# Guadalupe Delta WMA- ADA Evaluation

**Accessibility Evaluation**

**Inspection Date: 01/05/2022**

**Report Date: 01/21/2024**

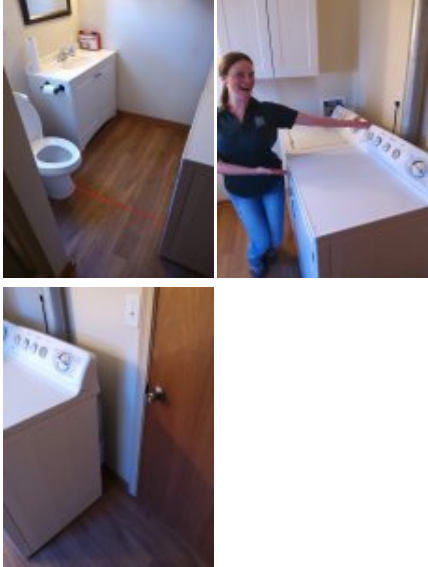
Finding Number	Area Description	Finding	As Built	Recommendation	Citation	Photos	Figure
3	Exterior of Property (Public): Parking Lot ( 0 Spaces) - Access Aisle Requirments (Van)	The access aisle is in not nearly compliant. The access ai the minimum width. The access aisle is not as long as the parking space it serves. There are no markings to discourage parking. The floor or ground surface is not firm stable or slip resistant. The parking space contains changes in level and/or gaps that exceed the maximum allowable requirements.	There is no access aisle provided. Gravel surfacing material is not compliant for access aisle and missing boundary markings. Access aisle width requirments depend on van stall size. van stall 11' access aisle 5' or van stall 8' access aisle 8'	https://www.access-board.gov/ada/#ada-502_3	2012 TAS Section: 502.3 2010 ADAS Section: 502.3 2015 ABAAS Section: 502.3
